Board Staff Interrogatories

2011 IRM2 Electricity Distribution Rates Middlesex Power Distribution Corporation - Dutton ("Middlesex Power - Dutton") EB-2010-0274

Sheet B1.1 Rate Class and RTSR Rates is reproduced below.

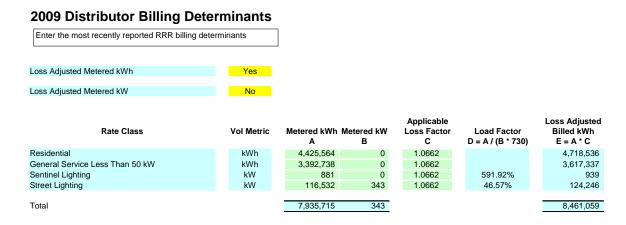
a) Middlesex Power – Dutton current Tariff of Rates and Charges does not match with the Tariff of Rates and Charges prepared in the 2011 IRM2 RTSR Adjustment Workform. Board Staff notes that RTSR – Network and RTSR – Connection for the Residential, GS <50 kW, Sentinel Lighting and Street Lighting classes are different from those which appear in the approved 2010 tariff sheet.

If these rates are correct, please explain why. If not, please identify the correct rates for RTSR – Network and RTSR – Connection for the Residential, GS <50 kW, Sentinel Lighting and Street Lighting classes and Board Staff will adjust the filed RTSR Adjustment Workform.
